Re: Daylight and Sunlight: 25/02161/FUL: Christs College Library, St Andrews Street, Cambridge CB2 3BU

Demolition of 1970s library and replacement with new library and social and study spaces and including re-provision of bridge to the Bodley Library.

Figure 1: Extract of Applicant's Shading Study Clearly Showing Additional Effects of Scheme

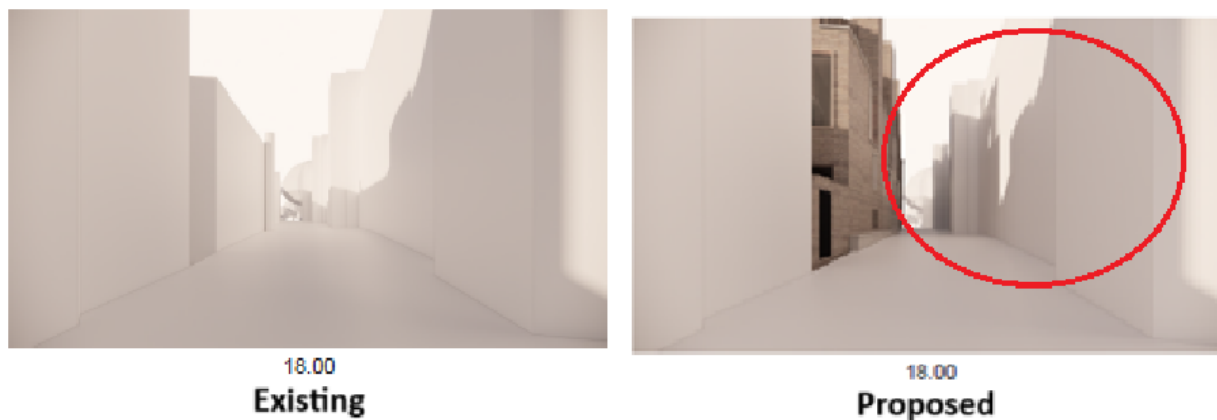
These changes are most clearly illustrated by the change in shading patterns extracted below showing darker shadows cast across the lane at 6pm on the summer solstice.

The assessments of shading on other dates within the architect's study appear inaccurate or difficult to judge. The image at 1800 on the equinox is presented in a pink blush and the images presented at 1800

on the winter solstice are effectively pitch black. Whilst this may represent a post sunset condition it clearly is not an 'accurate and objective' assessment as suggested by Turley.

The study presented does not accord with the BRE assessment criteria, shows only a limited angle of view, which appears to have been selected as favourable to the applicant and provides snapshots of selected dates including times where the shading effects are not legible.

It is clear that the proposal will have some shading effects which may affect the use of the lane which is not simply a transient passageway. A more comprehensive shading study would be required to fully understand the effects to the space. This should be produced by a specialist consultant and provide transient shadow paths comprising adequate dates, times and angles of view to fully enable an assessment of these potential impacts and to fully consider the concerns regarding the effect to the valuable public realm raised by the local community.

It is this shadow plotting, rather than the 2+ hour point in time study, that is required to fully assess the effects of the proposal. This should plot shadows across the areas of public realm and sitting out spaces at adequate dates, times and angles of view to fully enable an assessment of these potential impacts. Such

Figure 2: Window map extract showing window 39

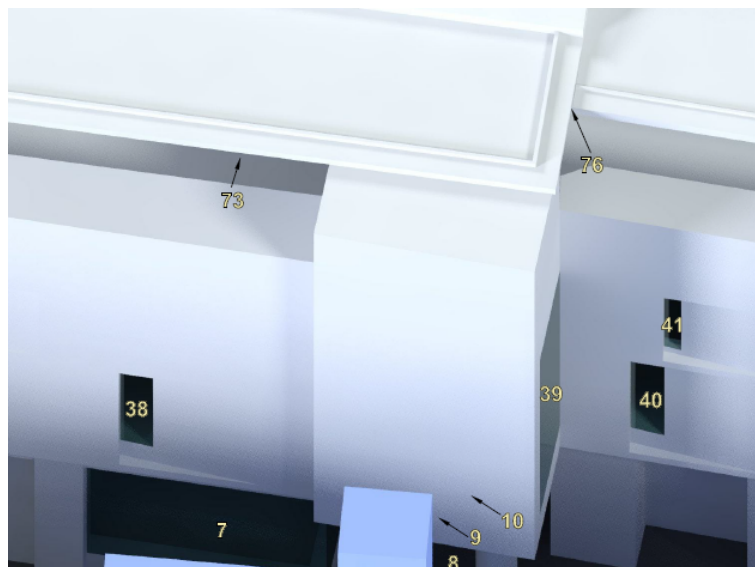
In the image window 39 can be seen to extend only to the level of the first floor retail. In reality the window continues to serve the upper floor area as shown below:

The position of window 39 is relevant in the assessment of the neighbouring window 76 which is recessed behind window 39. Further sky visibility may be received to window 76 through this aperture and any additional benefit or reduction cannot be quantified if window 39 is not accurately modelled.

The inaccuracy in modelling an area where there is acknowledged to be a deviation from the BRE targets is of concern. This is particularly the case as it is understood that ensuring an accurate assessment was raised as a key consideration between officer's and the applicant team during pre-application discussions. When Turley noted they did not have accurate plans of Bradwell Court the officer recommended that neighbours be approached at the consultation event to confirm the layouts and / or grant access to their flats. I understand that the applicant did not contact neighbours or seek access to any of the flats to validate the findings of their survey.

Given the issues noted above updated modelling should be provided prior to the determination of the application. This should rectify the issues identified in respect of window 39 and ensure that drawings are provided that confirm the accuracy of the 3d modelling work.
